Alissa Sluys Consents and Hearings Administrator Northland Regional Council

Thank you for sending details relating to APP.039650.01.01, ADDENDUM TO S42A report by Melanie Donaghy and further AECOM and Tonkin & Taylor reports, which I would like to comment on.

Mudcrete Grid

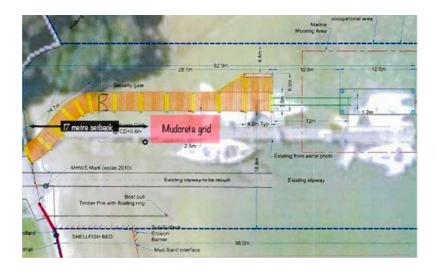
If a grid was installed, **there is a high risk of direct discharge into the CMA** should a pump be subject to blockages which can occur. An operator could be focussed entirely on his boatwork and may not be aware when a blockage occurs while working on the opposite side until after an overflow ensued.

It should be noted that many operators would be boat owners using this equipment for the very first time and a workable, loud alarm system must be fitted. An emergency plan needs to be detailed.

Due to recent developments I now believe, that an appropriately placed, well planned, well run and well supervised mudcrete grid could be acceptable and justified. It may well be an asset to the community, providing restrictions were made as to its use.

These must be confined to biosecurity and hull inspections, soft hand cleaning or washing with low pressure water, scraping only, and minor replacements such as anodes, hull fittings and work with propellers.

I believe there is support for one mudcrete grid that did not risk damage to the CMA or impaired the visual and natural environment in any way. To achieve this a minimum setback of 17 metres seaward from the beach is necessary, so that the scenery shown in photos provided is not obscured.
